PROJECT MANAGEMENT PLAN

Burwood North Station Construction Traffic Management Plan

Sydney Metro - West

SMWSTSPW-GEA-BWT-PM-PLN-000001

Figure 10: Approved Heavy Vehicle Routes

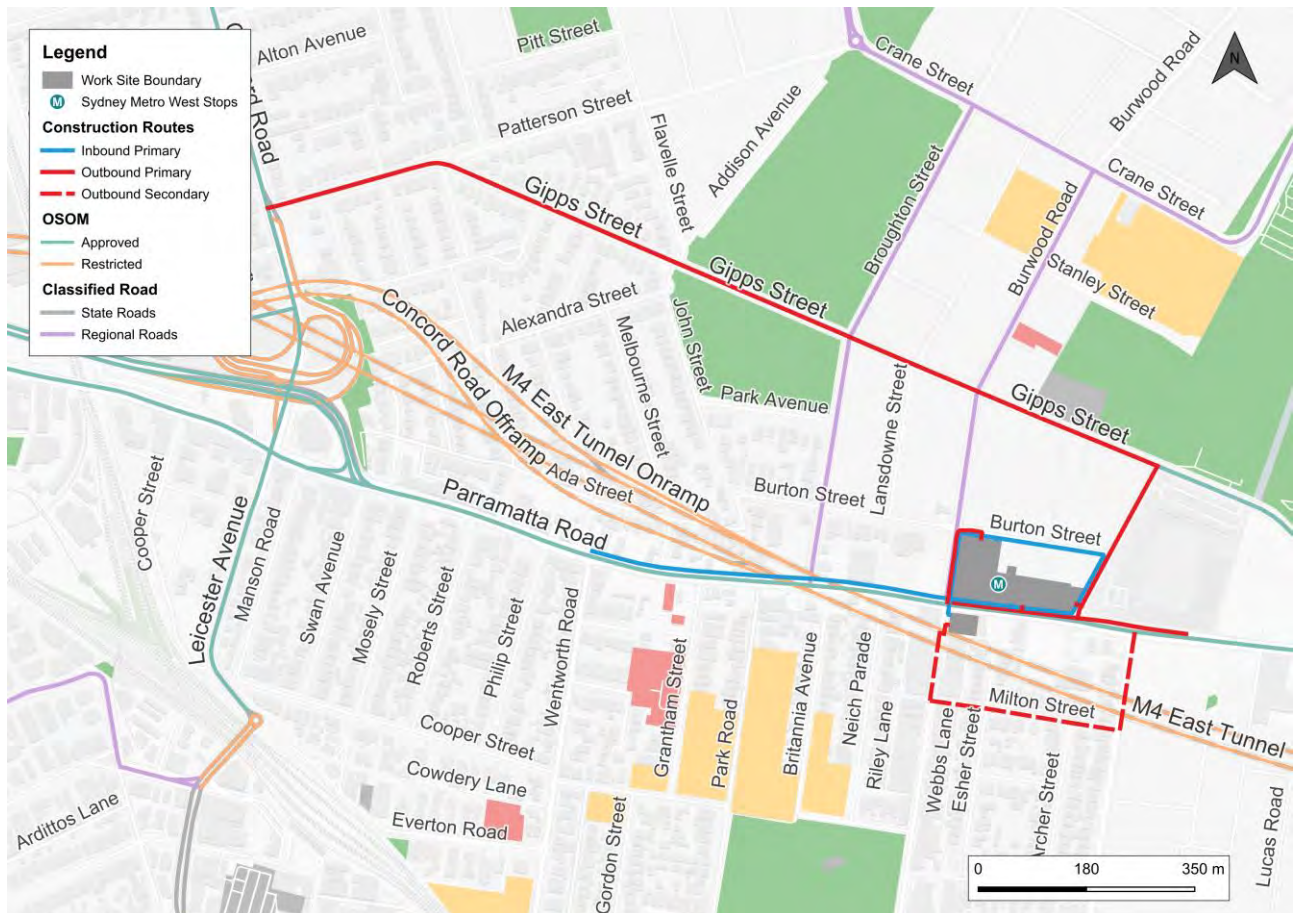
45	23/06/2026	CCB	LHUANG	SMWSTSPW-GEA-BWT-PM-PLN-000001	Figure 10	N/A	Figure 10. Approved Heavy Vehicle routes notification must be provided to the residents along the outbound route on Gipps Street/ Patterson Street and Milton Street / Shaftesbury Road. Figure 10 and 11 to also be included within the notification to advise of heavy vehicle movements due to previous residential complaints.	Potential Non-Compliance		N
				SMWSTSPW-GEA-BWT-PM-PLN-000001	Figure 10	N/A	Gamuda issues monthly works notifications to residents around the Burwood North site, with the distribution area extending to 100 metres from the construction site for work taking place during the day, and 200 metres for work taking place at night. Gamuda also issues project newsletters to properties 500 metres from site as well as email distribution. Monthly notifications include details on any scheduled large deliveries, traffic impacts and contact details for the project. Gamuda has a complaints management process to address all complaints relating to construction immediately as they arise. All complaints will be answered and responded to 24 hours per day, seven days per week. The project has the ability to track and identify trucks travelling to site through our logistics management system, so that we can directly manage vehicles travelling to site.	Potential Non-Compliance		N

Figure 36: Carparking Survey Location

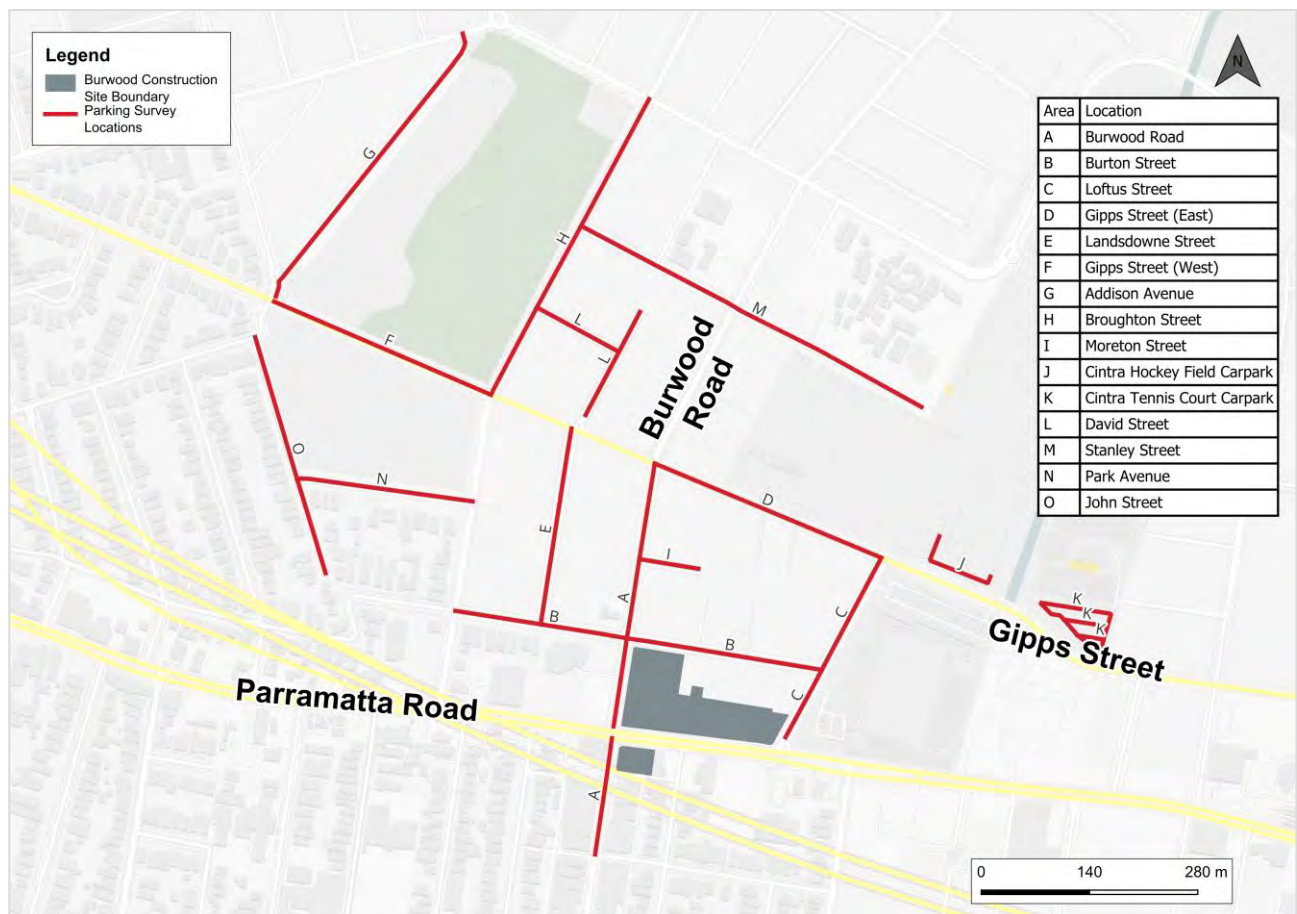
NO.	DATE	COMPANY	RAISED BY	REVIEW DOC. NO.*	DOCUMENT REF*	DEED REF*	COMMENTS / RESPONSE	COMMENT CATEGORY*	LINKED ITEM NO	CLOSED OUT
07	17/06/2026	SCO	PKEYES	SMWSTSPW-GEA-BWT-PM-PLN-000001	Clause 7.2	.	Figure 35: The survey area should also include the hockey and tennis centre carparks on the northern side of Gipps St between Loftus St and Taylor St. Also include Moreton St (off Burwood Rd)	Observation		N
				SMWSTSPW-GEA-BWT-PM-PLN-000001	Clause 7.2	.	Addressed. Figure 35 has been updated to include the hockey and tennis centre carparks on the northern side of Gipps Street between Loftus Street and Taylor Street within the parking survey area.	Observation		N
08	17/06/2026	SCO	PKEYES	SMWSTSPW-GEA-BWT-PM-PLN-000001	Clause 11	.	A Conclusion is not required in a TMP. Remove Clause	Observation		N
				SMWSTSPW-GEA-BWT-PM-PLN-000001	Clause 11	.	Removed the Conclusion section and updated the contents page and cross-references accordingly.	Observation		N

48	23/06/2026	CCB	LHUANG	SMWSTSPW-GEA-BWT-PM-PLN-000001	Figure 35	N/A	Figure 35, the survey area will require expansion to include Burton Street, John Street, Park Avenue, David Street and Stanley Street as these locations are within walking distance to the site with unrestricted parking. Please provide the data to Council for future use and comparison needs once the Metro is operational.	Potential Non-Compliance		N

NO.	DATE	COMPANY	RAISED BY	REVIEW DOC. NO.*	DOCUMENT REF*	DEED REF*	COMMENTS / RESPONSE	COMMENT CATEGORY*	LINKED ITEM NO	CLOSED OUT
				SMWSTSPW-GEA-BWT-PM-PLN-000001	Figure 35	N/A	Figure 35 has been updated for the expansion	Potential Non-Compliance		N
49	23/06/2026	CCB	LHUANG	SMWSTSPW-GEA-BWT-PM-PLN-000001	Section 7.4	N/A	Section 7.4 - Remove error note.	Potential Non-Compliance		N
				SMWSTSPW-GEA-BWT-PM-PLN-000001	Section 7.4	N/A	Addressed. The error note in Section 7.4 has been removed.	Potential Non-Compliance		N
50	23/06/2026	CCB	LHUANG	SMWSTSPW-GEA-BWT-PM-PLN-000001	Section 7.7	N/A	Section 7.7 - Remove Inner West Council and update with City of Canada Bay Council and Burwood Council	Potential Non-Compliance		N
				SMWSTSPW-GEA-BWT-PM-PLN-000001	Section 7.7	N/A	Addressed. Section 7.7 has been updated to remove Inner West Council and refer to City of Canada Bay Council and Burwood Council where relevant.	Potential Non-Compliance		N
